ANN ARBOR HISTORIC DISTRICT COMMISSION

Staff Report

ADDRESS: 502 East Ann Street, Application Number HDC25-0069

APPLICATION: The applicant seeks HDC approval to remove one third-floor rear window, increase the opening size, and install a new hung window.

EXTERIOR ELEVATION

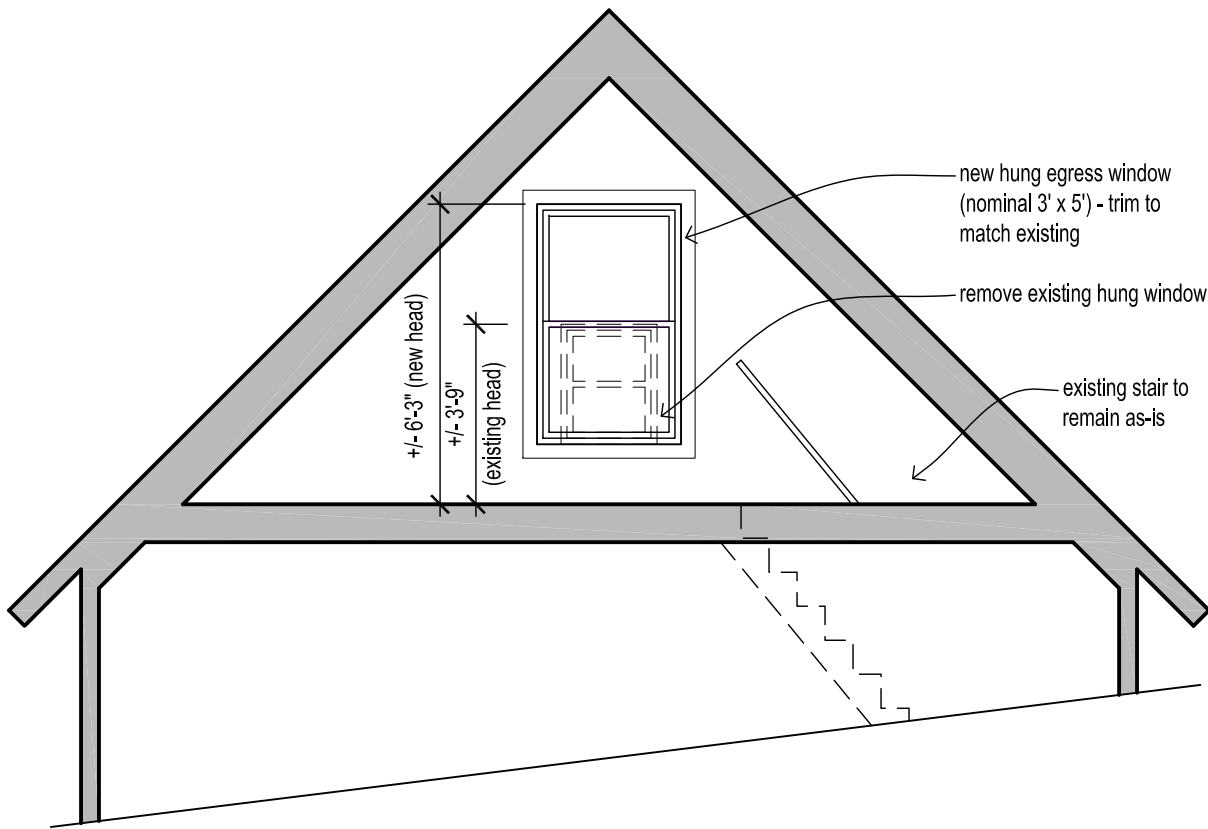
1. According to the application, the window needs to be enlarged and replaced to meet egress requirements. The new window will measure approximately 3 feet by 5 feet. The location at the rear of the house is appropriate for an egress window as it will be minimally visible.
2. The third-floor rear window opening is assumed to be historic because the size and trim match the third-floor window on the front elevation of the house. It is unclear based on the application if the window itself is historic.
3. The applicant has not provided details on the proposed replacement window and trim, so staff has added conditions to the motion to specify materiality of the new window and trim.

I move that the Commission issue a certificate of appropriateness for the application at 502 East Ann Street, a contributing property in the Division Street Historic District, to remove a third-floor rear window, enlarge the opening, and install a replacement window on the conditions that 1) the replacement window is wood or clad wood and 2) the new trim is wood and slightly differentiated from the historic trim and the trim dimensions are submitted to staff prior to building permit approval. As conditioned, the work is compatible in exterior design, arrangement, texture, material and relationship to the rest of the building and the surrounding area and meets *The Secretary of the Interior's Standards for Rehabilitation and Guidelines for Rehabilitating Historic Buildings*, in particular standards 2, 5, and 9, and the guidelines for building site and windows, as well as the *Ann Arbor Historic District Design Guidelines* for windows.
